SEWAGE DISPOSAL SYSTEM

HOWARD COUNTY HEALTH DEPARTMENT

SUBDIVISION The Woods at Ridgeview LOT Parcel 4 ROAD 15074 Frederick Road

CLARK • FINEFROCK & SACKETT, INC. ENGINEERS • PLANNERS • SURVEYORS		
7135 MINSTREL WAY • COLUMBIA, MD. 21045 • (410) 381-7500 - BALTO. • (301) 621-8100 - WASH.		
DESIGNED <i>Ar</i>	SITE DEVELOPMENT PLAN PARCEL 4 WOODS AT RIDGEVIEW FOURTH(4TH) ELECTION DISTRICT HOWARD COUNTY, MARYLAND	SCALE 1"=50'
DRAWN <i>Ar</i>		DRAWING 1 of 1
CHECKED		JOB NO. 08-042
DATE 11-19-98		FOR: CROSEN HOMES 3775 Shady Lane Glenwood, Maryland 21738

Approved Septic System Plan
 Howard County Health Dept
 600115335 - 4B

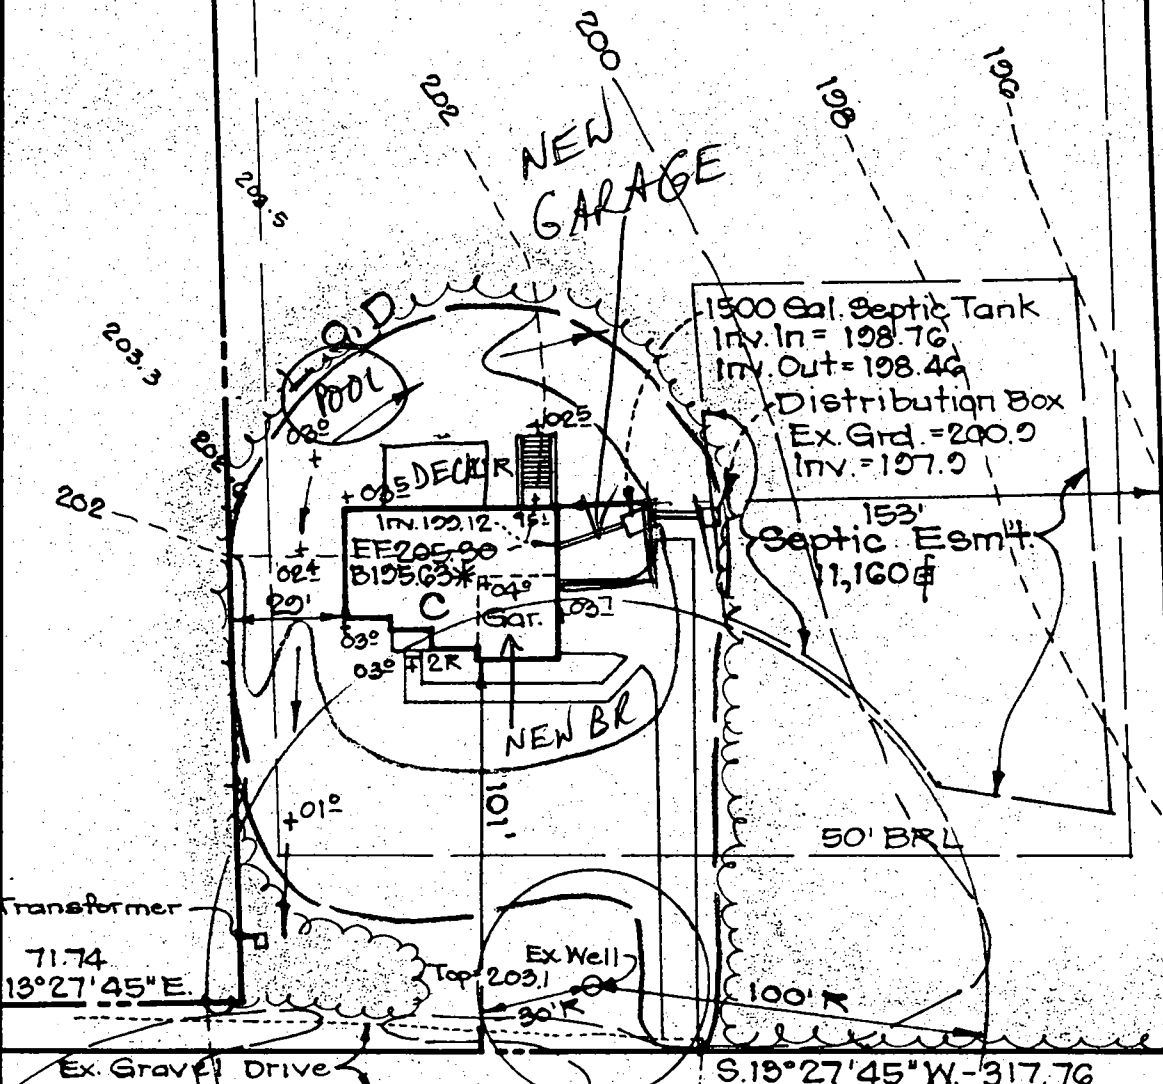
3/19/04 MTG w/ OWNER RE: POOL, DECK, NEW BR, NEW GARAGE

(MR) ADVISED HER POOL & DECK OK AS SHOWN
 NEW BR WOULD NEED TANK UPGRADE TO 1500 GAL
 NEW GARAGE WOULD NEED TANK LOCATION 10' AWAY &
 VERIFICATION THAT EX. D.B. / TRENCHES 10' AWAY
